**N5181A-03**

## N5181A MXG Analog Signal Generator

**“Batch related power supply issue may result in a non-functioning instrument”**

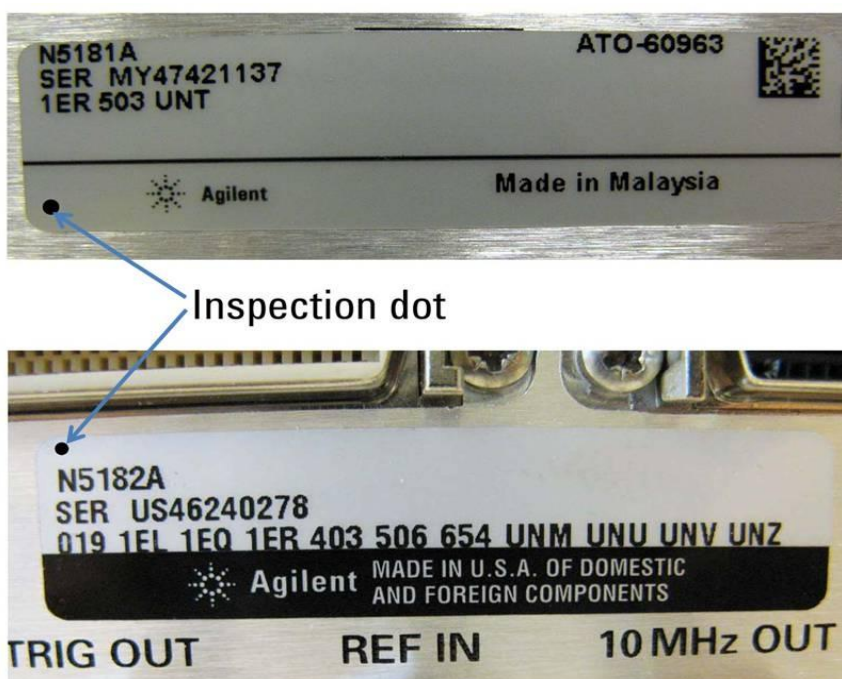
1. For a suspected N5181A, check the rear panel serial tag for a small black inspection dot (see images below). If a black dot is present, similar to what is depicted, the instrument has been checked or previously repaired and no further action is required
2. If the dot is missing proceed to step 3.

3. Remove the external and then the internal top cover; using the instructions in the MXG Service Guide.
4. Check the A1 power supply serial number. (See images below for location and examples). The power supply identification label can be located on either the top or sides of the power supply.

The serial numbers below are the 10 alpha-numeric digits on the identification label. In the following examples the formatting is different between identification labels. The serial numbers depicted are KR73502511 and KR73501295.

6. Following the step by step instructions in the MXG Service Guide, remove and replace the power supply.
7. Following the instructions in the MXG Service Guide, re-assembly the MXG.
8. Following the Manual Performance Tests documented in Chapter 4 of the Service Guide, perform instrument Self Tests.
